**Subject: Response to NRC Request for Additional Information Letter No. 16
Related to ESBWR Design Certification Application – Piping Design –
RAI Numbers 3.12-1 through 3.12-37**

1. MFN 06-119 – Response to NRC Request for Additional Information Letter No. 16 Related to ESBWR Design Certification Application – Piping Design – RAI Numbers 3.12-1 through 3.12-37

Response to NRC Request for Additional Information

Piping Design

Figure 3.7-37. Alternative Damping Values for Response Spectra Analysis of ASME Section III, Division 1 Class 1, 2, and 3, and ASME/ANSI B31.1 piping systems

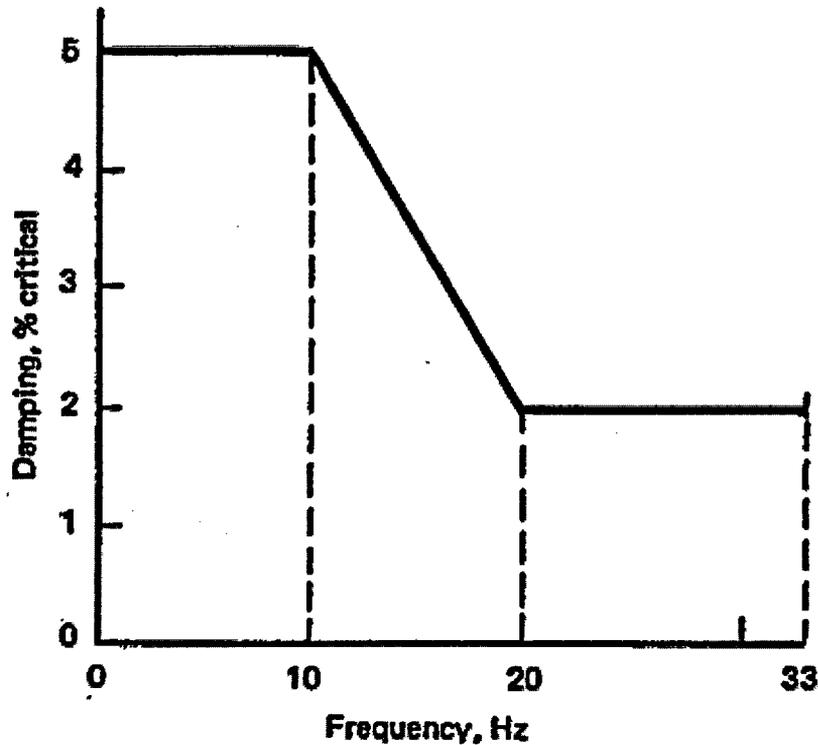
DCD Tier 2, Section 3.7.1.2 and Table 3.7-1 specify damping values to be used in the seismic analysis of SSCs. The DCD indicates that ASME Code Case N-411-1 may be used as permitted by RG 1.84 in place of Regulatory Guide 1.61 damping values. As indicated in RAI 3.12-2, Code Case N-411 has been annulled by the ASME. The DCD also indicates that ASME Code Case N-411-1 damping cannot be used for analyzing linear energy absorbing supports designed in accordance with ASME Code Case N-420. Indicate whether the damping values, corresponding to Code Case N-411-1 and meeting the conditions listed in Table 4 of RG 1.84, Rev. 33, will be used for the independent support motion (ISM) method. If the Code Case N-411-1 will be used, then provide the technical basis for using these damping values with the ISM method.

References to ASME Code Case N-411-1 are being deleted from Section 3.7 in DCD Revision 2. To maintain this option in the ESBWR design, N-411-1 damping curve and associated conditions permitted by RG 1.84, including the limitations for use with the ISM method, will be explicitly described. Markups of the affected DCD pages are attached.
